**ADDENDUM  
NO. 2**

**October 21, 2022**

**Additions & Renovations to Eastridge Elementary School**  
10930 East 10<sup>th</sup> Street  
Indianapolis, IN 46229

PROJECT NO: 2021055

DRAWING NUMBER  
**L101**

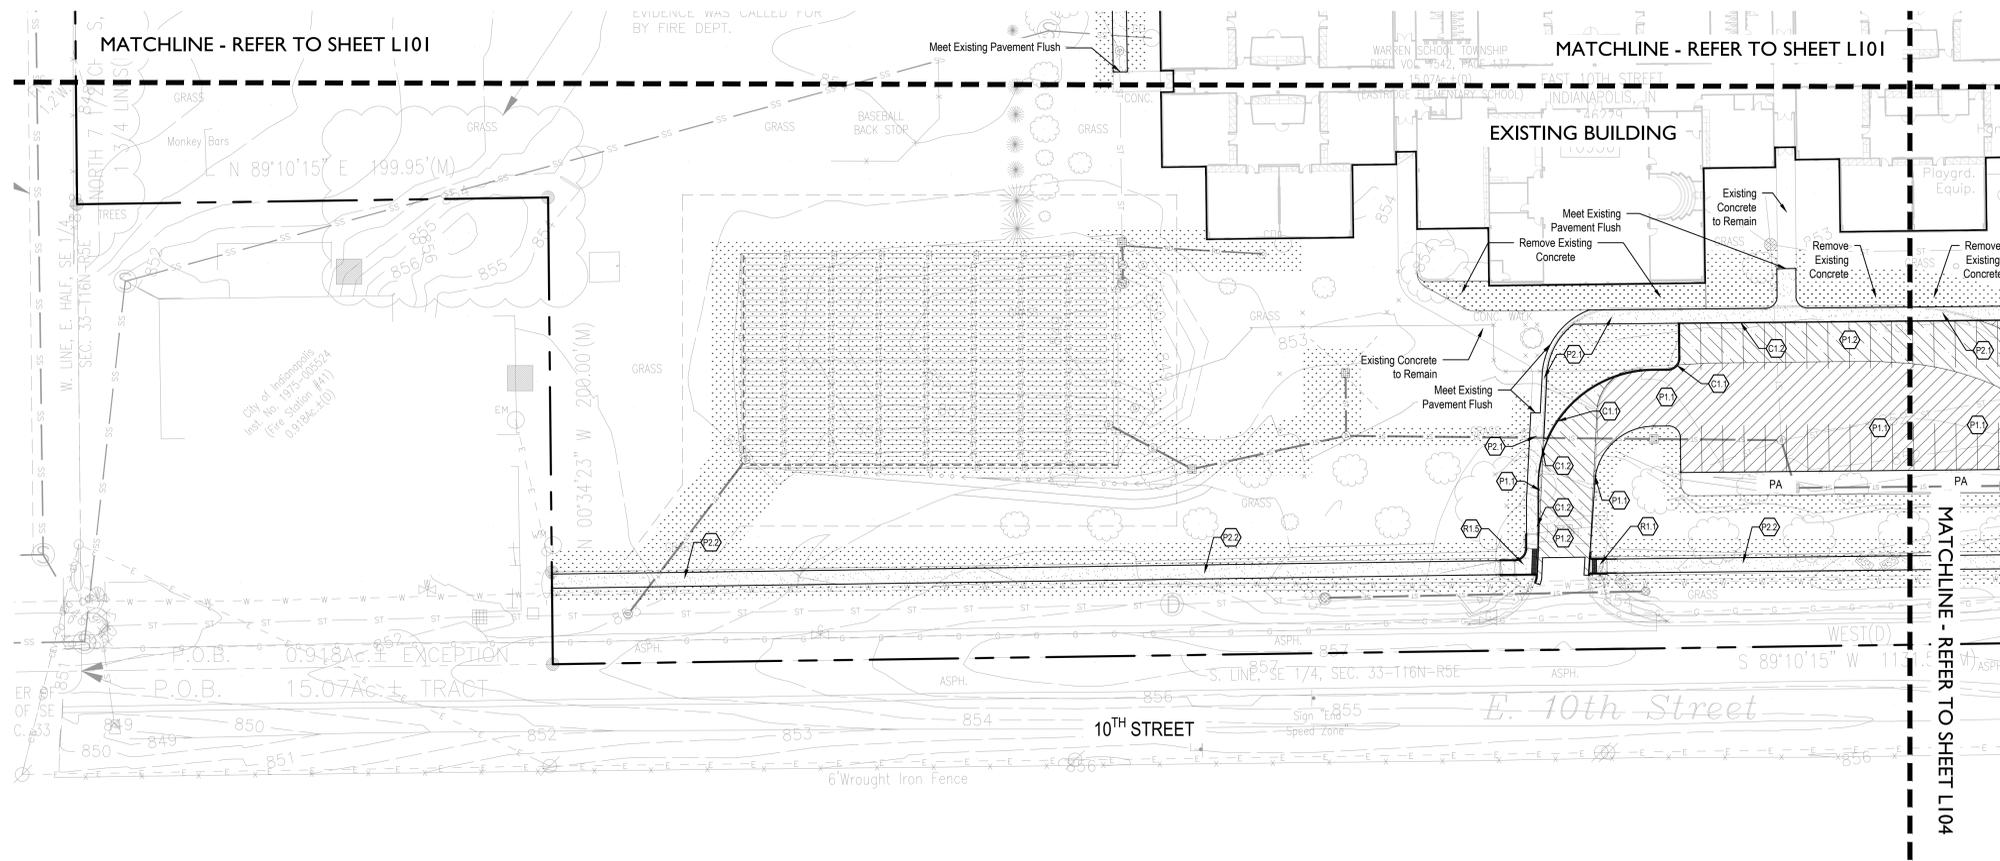
- 3.1 L101 MATERIALS PLAN
  - A. Legend updated to clarify Curbing conditions.
- 3.2 L102 MATERIALS PLAN
  - A. Legend updated to clarify Curbing conditions.
- 3.3 L103 MATERIALS PLAN
  - A. Legend updated to clarify Curbing conditions.
- 3.4 L104 MATERIALS PLAN
  - A. Legend updated to clarify Curbing conditions.
- 3.5 L201 ENLARGED PLAYGROUND MATERIALS PLAN
  - A. Legend updated to clarify Curbing conditions.

**DRAWING NUMBER:**  
 AD201B

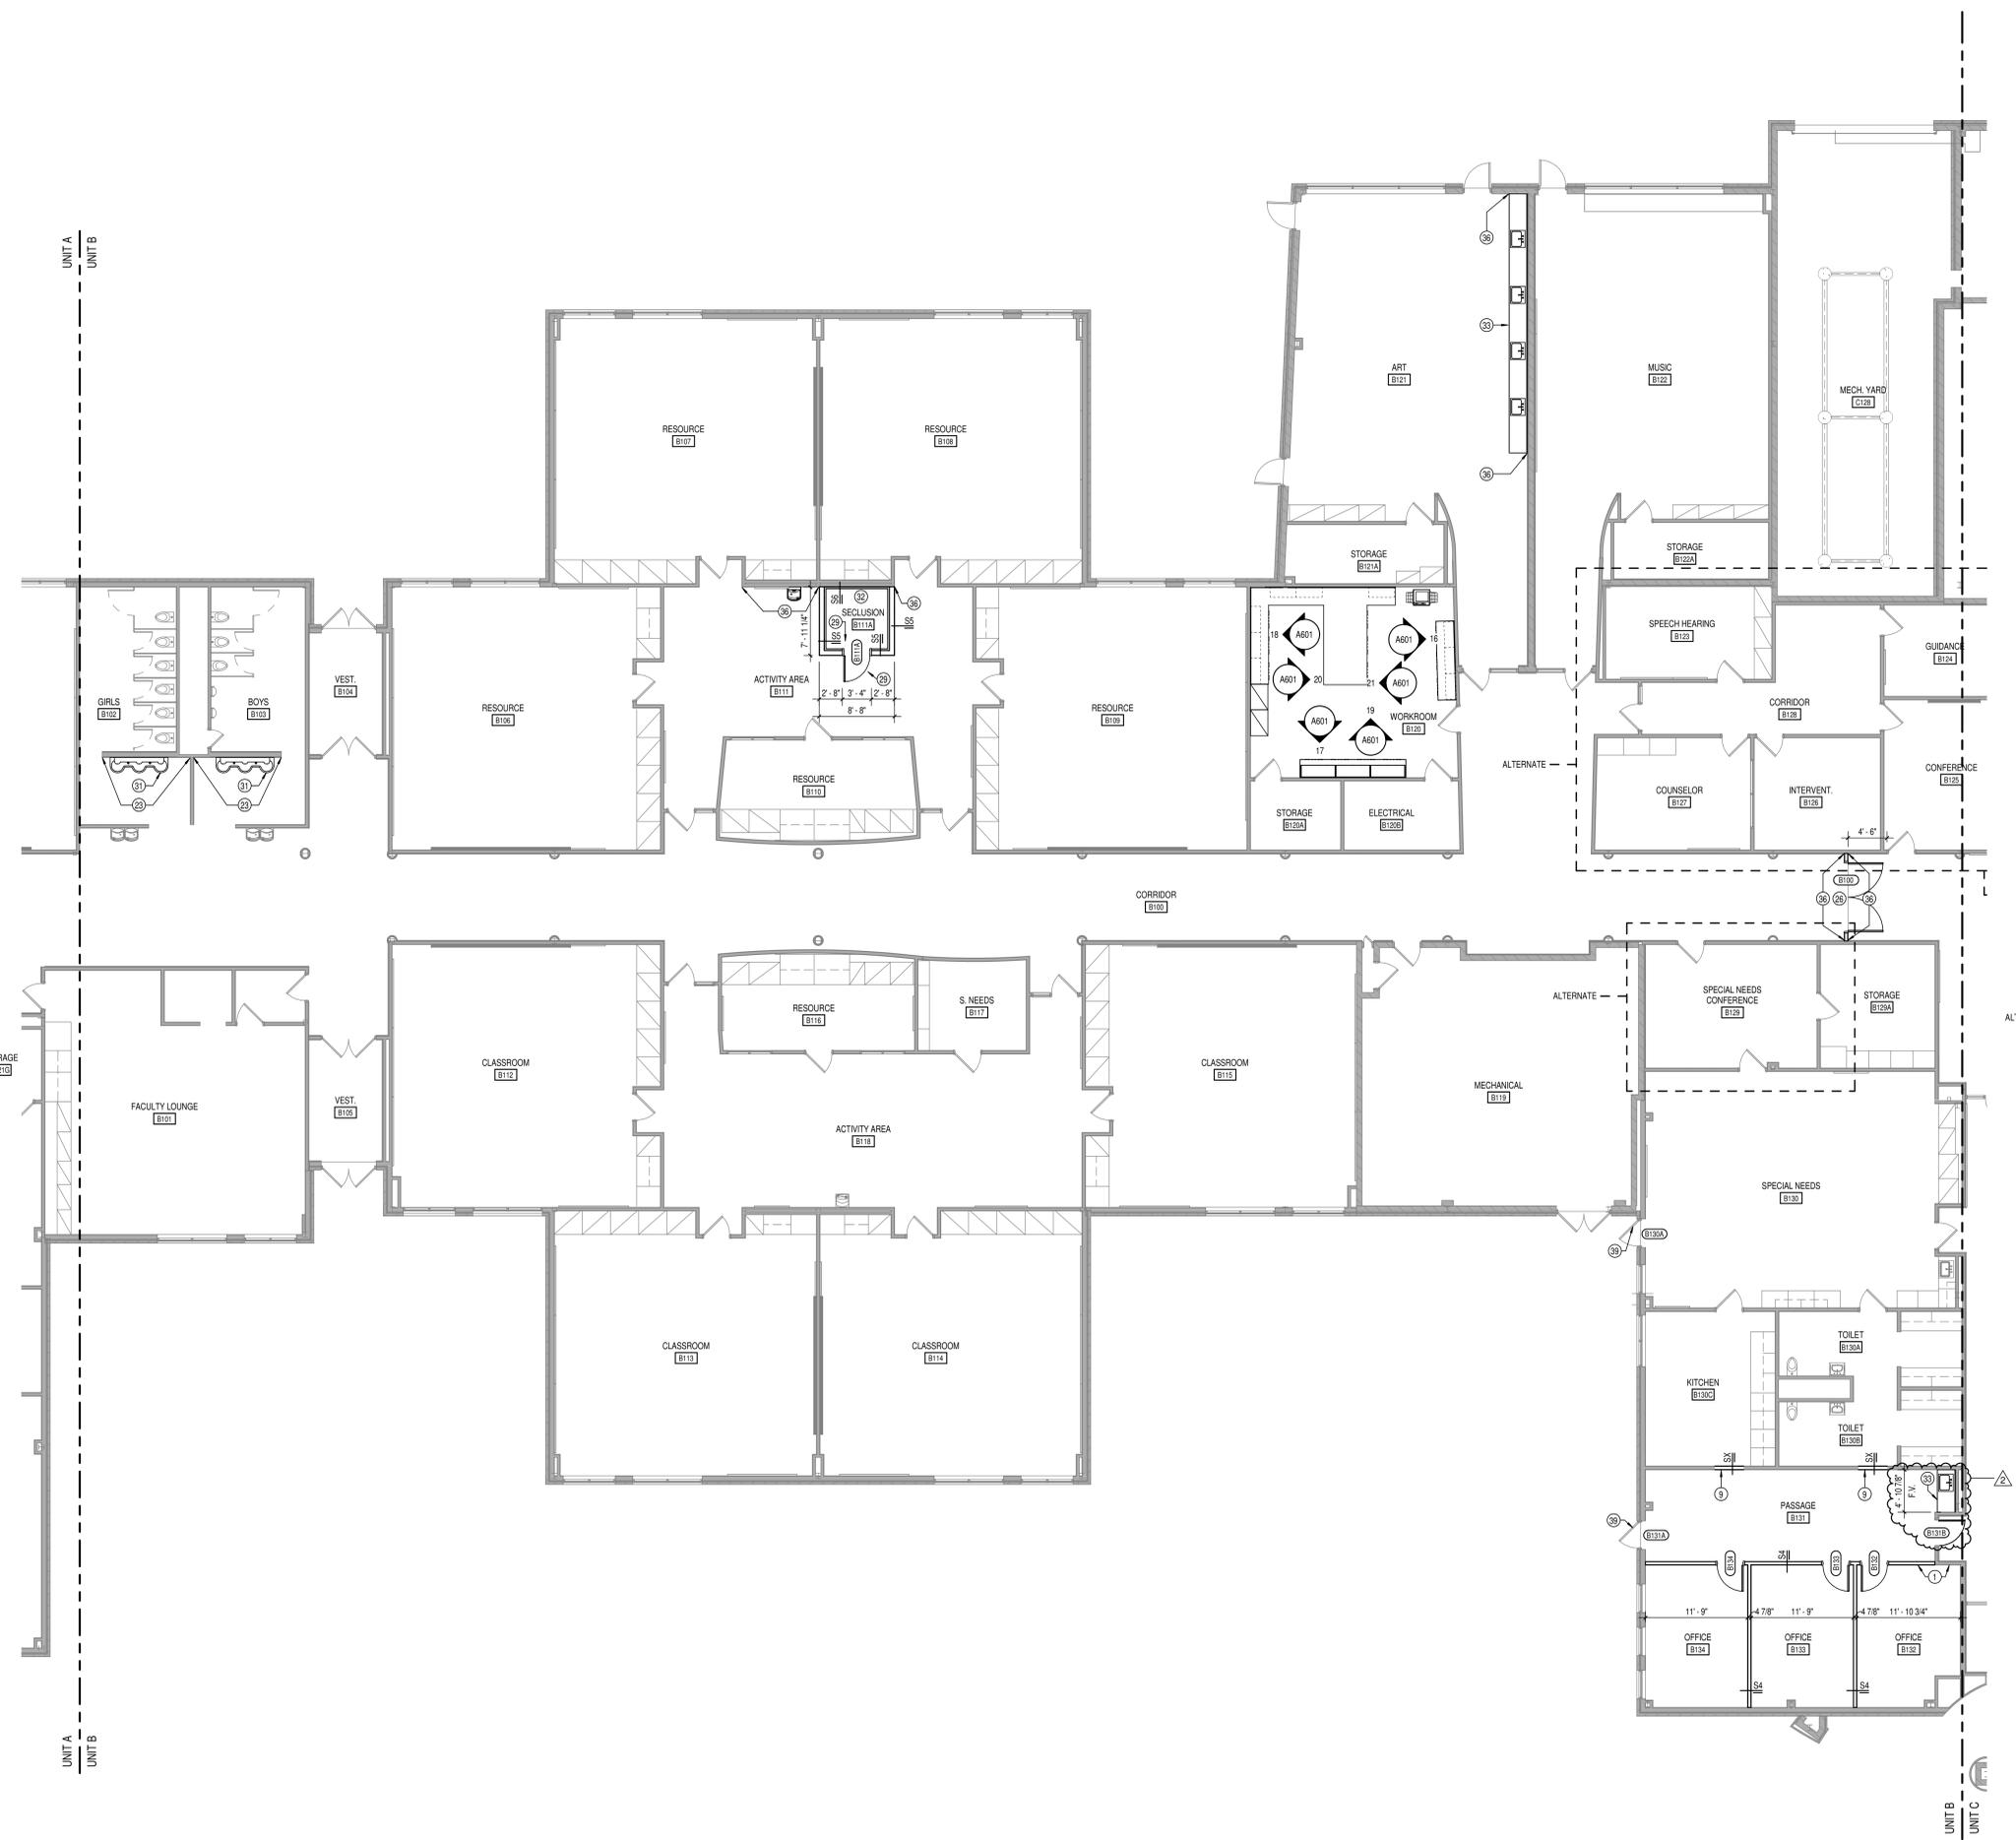
- 3.6 AD201B – FIRST FLOOR DEMOLITION PLAN UNIT B
  - A. Existing casework to remain at east wall of Special Needs Classroom. Remove existing countertop only. Salvage sink for re-installation in new countertop. Refer to Plumbing drawings. Demolish door B131B from existing frame to remain. See revised sheet AD201B, **attached**.
- 3.7 A201B – FIRST FLOOR PLAN UNIT B
  - A. Existing casework to remain at east wall of Special Needs Classroom. Provide new countertop. Provide new door B131B. See revised sheet A201B, **attached**.
- 3.8 A501 – DOOR SCHEDULE
  - A. Door B111A: revise as follows:
    - 1. Door to be extra-heavy duty type with midrail blocking
    - 2. Glass type to be 1/2" polycarbonate
    - 3. Lite kit to be metal with security screws on outside of room

**DRAWING NUMBER**  
**A201B**

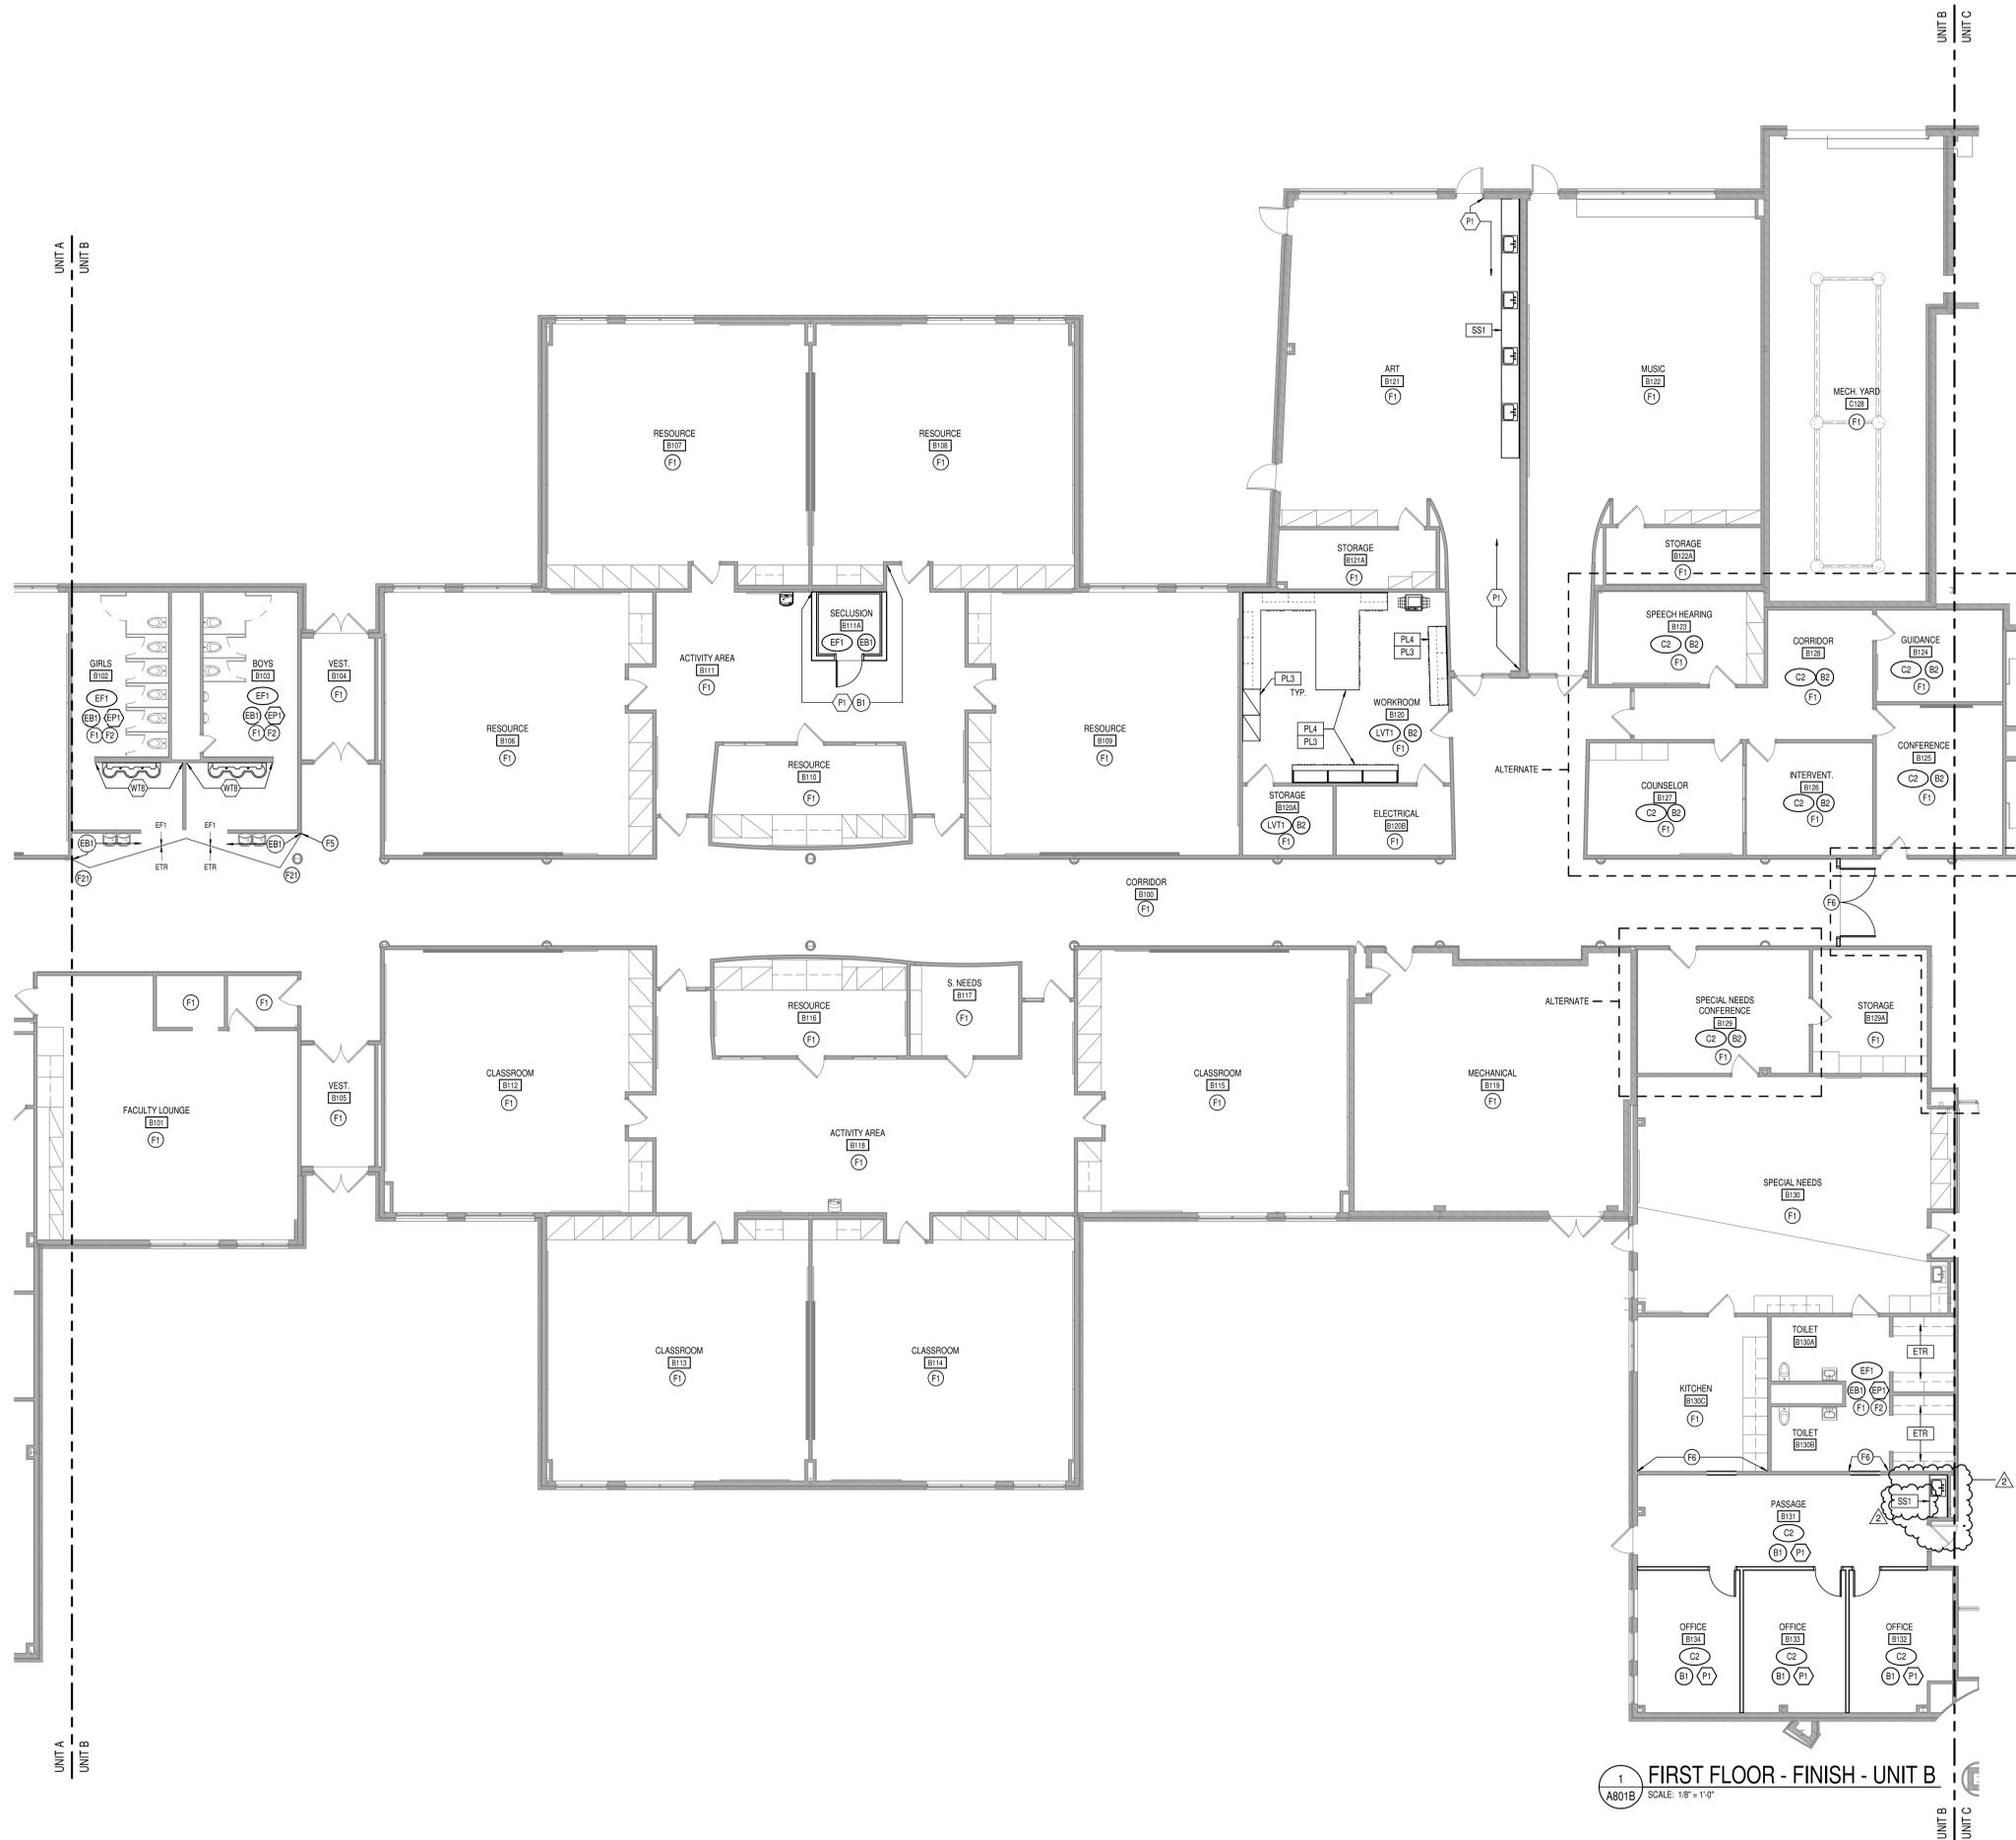
- B. Provide new door B131B, type D5, similar to existing but prepped as required for new hardware.
- C. General clarification: all existing door frames receiving new doors and / or hardware shall be painted to match balance of existing frames, typical.

1 FIRST FLOOR - FINISH - UNIT D  
A801D SCALE: 1/8" = 1'-0"

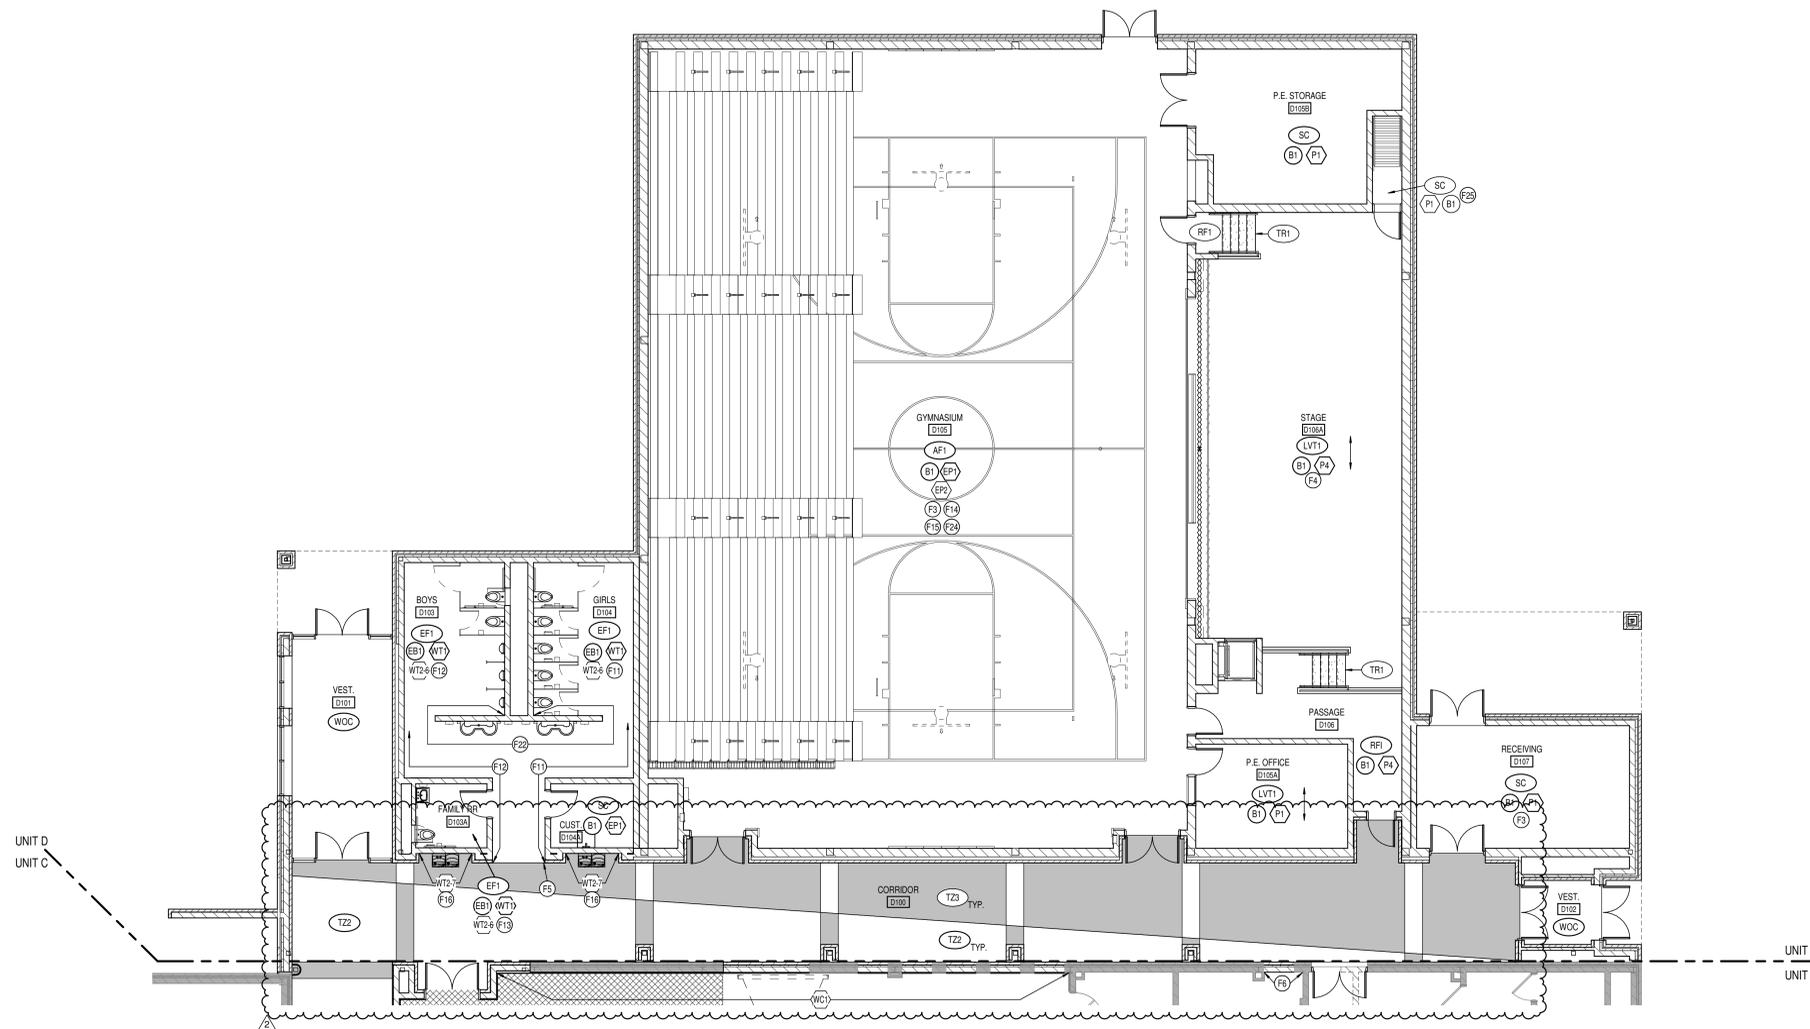
- A. Delete and replace entire sheet, **attached**.
- B. Added terrazzo floor pattern to CORRIDOR D100 and revised floor finish tags accordingly.
